MINISTRY OF TRANSPORTATION AND COMMUNICATIONS, ONTARIO

FOUNDATION INVESTIGATION REPORT
For
The Proposed Remedial Measures
Of the East Approach of the
Blanche River Bridge
Site 47-216
Twp. of Casey, Dist. of Timiskaming
District #14, New Liskeard
W.O. 73-11095(R) W.P. Nil

BLANCHE RIVER BRIDGE
PROPOSED REMEDIAL MEASURES TO STABILIZE
EAST END FORWARD SLOPE

Re: Blanche River Bridge at Belle Vallee, Lot 4, Con. 5 & 6,
Twp. of Casey, Site #47-216, District #14, New Liskeard

DWG. NO. 73-11095 B

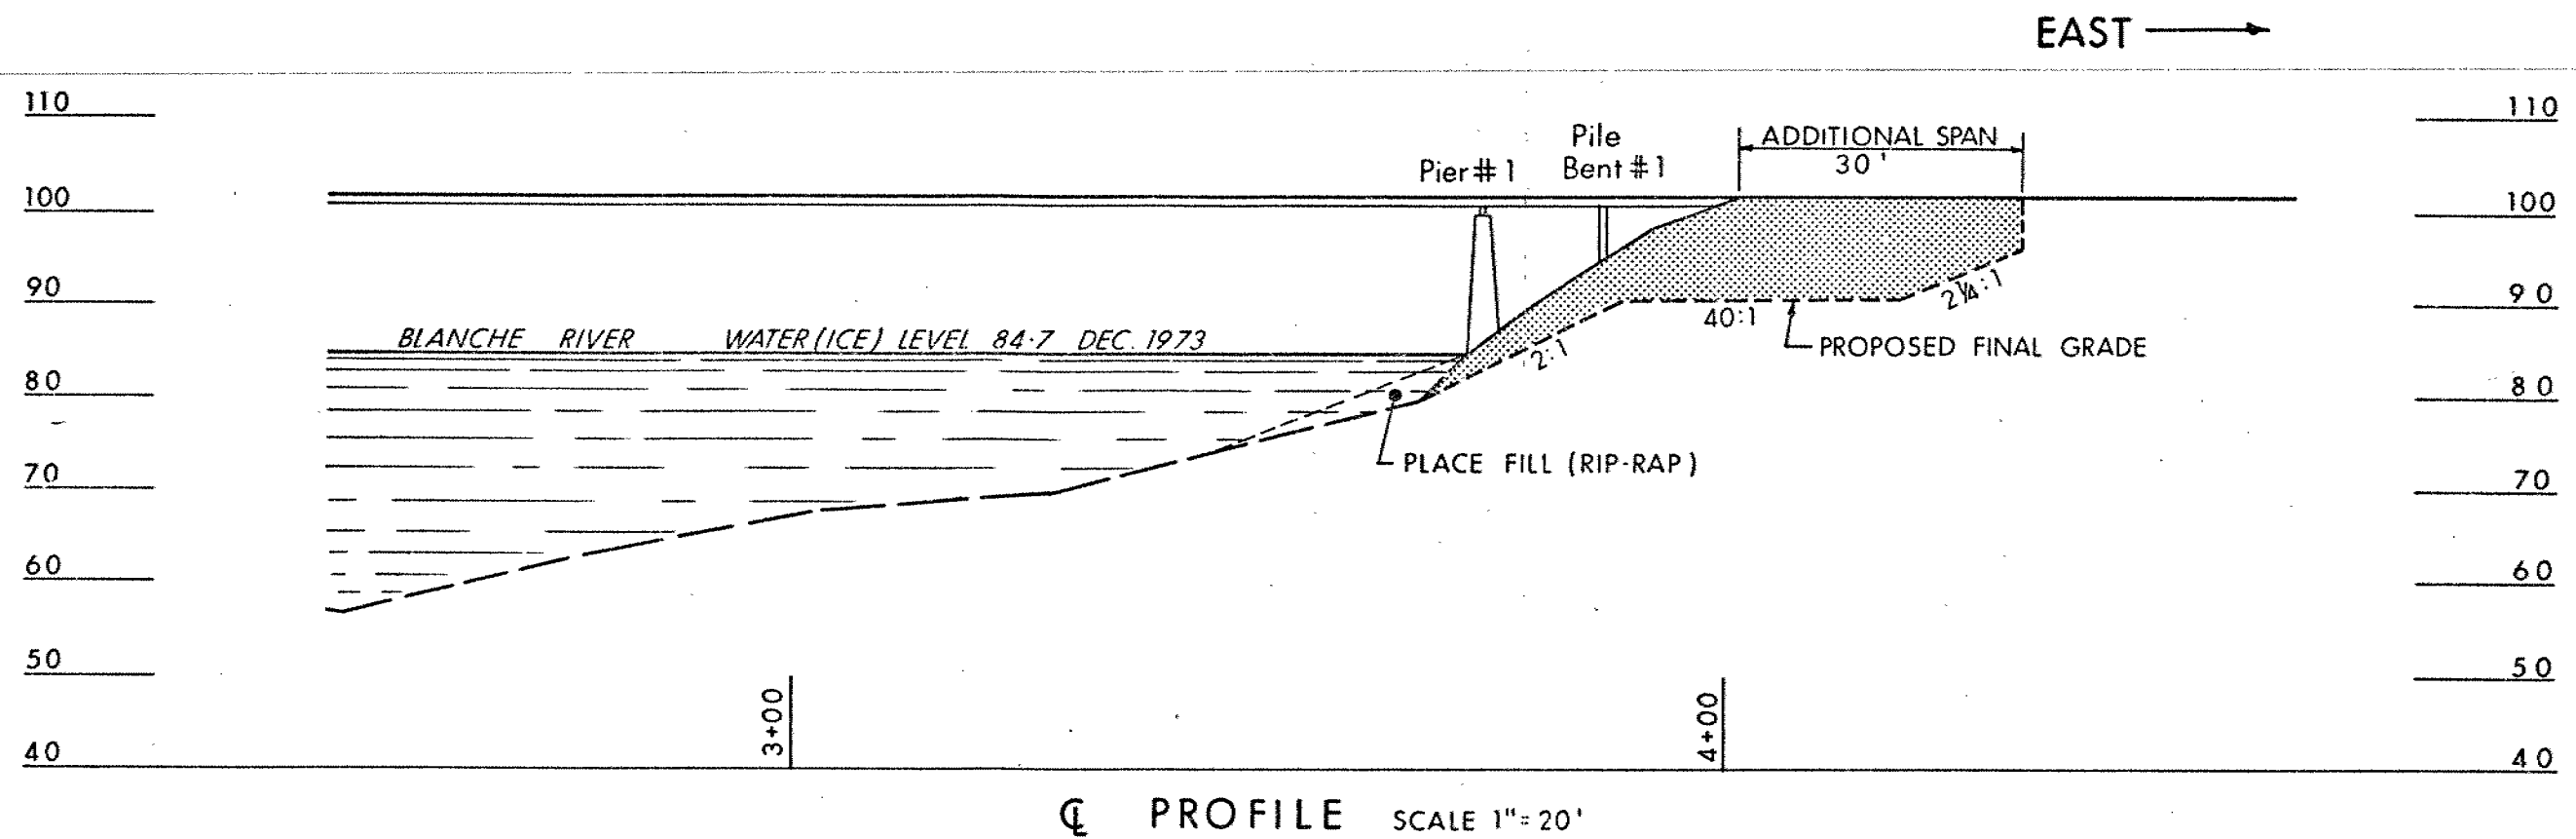
In order to ensure the longterm stability of the east approach it will be necessary to remove the fill material which overlies the soft, stratified clay subsoil in the manner described on the enclosed drawing no. 73 - 11095(R)B. This will result in a longer structure. The new, additional 30 ft. long span may be supported on timber piles driven at least 25 ft. into the original ground. The safe load carrying capacity of the piles may be calculated using the following formula:

In addition, Pier #1 should be repositioned. Rip-Rap should be placed in front of the pier where erosion has been observed.

- 1 - REMOVE EAST ABUTMENT, PILE BENT # 1 & BRIDGE DECK
- 2 - EXCAVATE SHADED AREA (AS SHOWN ON PROFILE) PROCEED FROM HIGHER LEVEL TO LOWER LEVEL
- 3 - DRIVE PILES, SAFE LOAD (PER PILE) = $L/3$ TONS (L=EMBEDDED LENGTH IN FT.)
MIN. EMBEDDED LENGTH 25'
- 4 - PLACE RIP-RAP ACCORDING TO HYDROLOGICAL REQUIREMENTS
